Proposed Revisions to a Standard Plans Index

Index Number: 430-022

Index Title: Side Drain Mitered End Section

SIDEDRAIN MITERED END SECTION
(Concrete Pipe Shown, Corrugated Metal Pipe Similar)

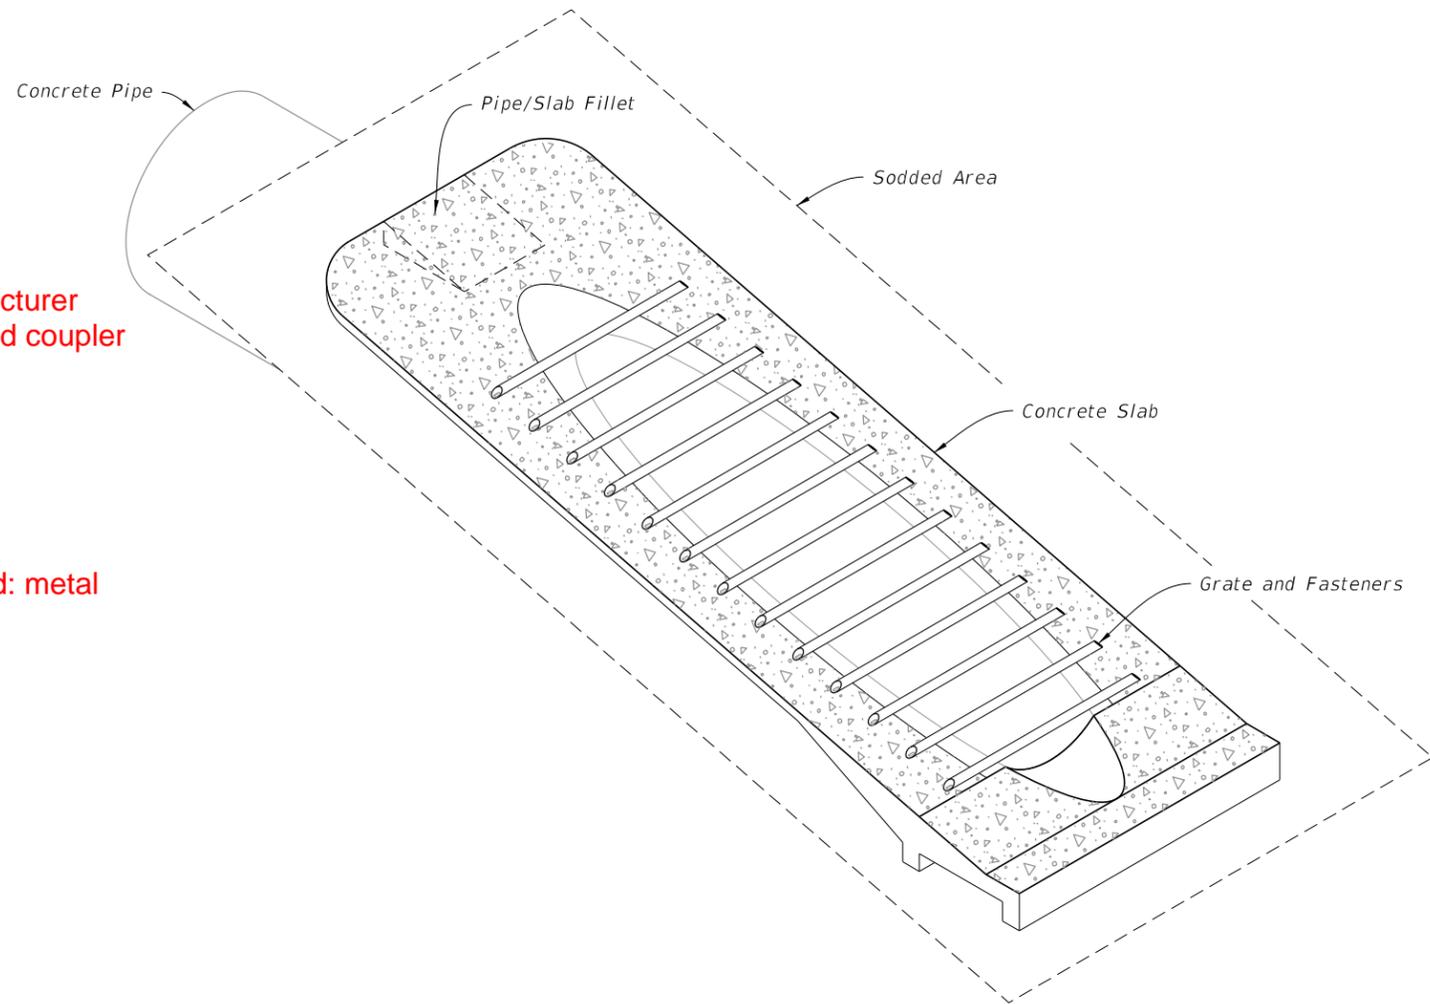
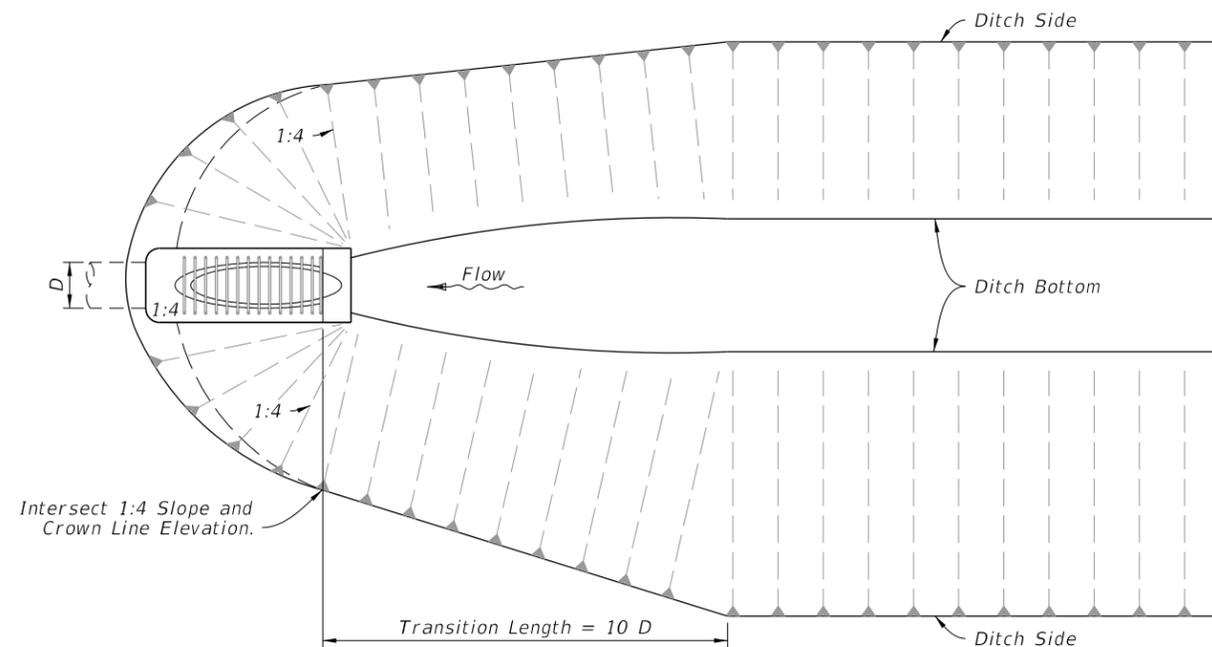
General Note 1: Added "or use manufacturer approved coupler" on the end

General Note 2: Added "metal" between corrugated and mitered. Delete "either."

or use manufacturer approved coupler

Deleted

Added: metal

Added "or use a manufacturer approved coupler" to General Note 1 for situations where concrete jacket is not used.

Deleted "either" from General Note 2 because it was left over from a previous edition. Added "metal" to specify material.
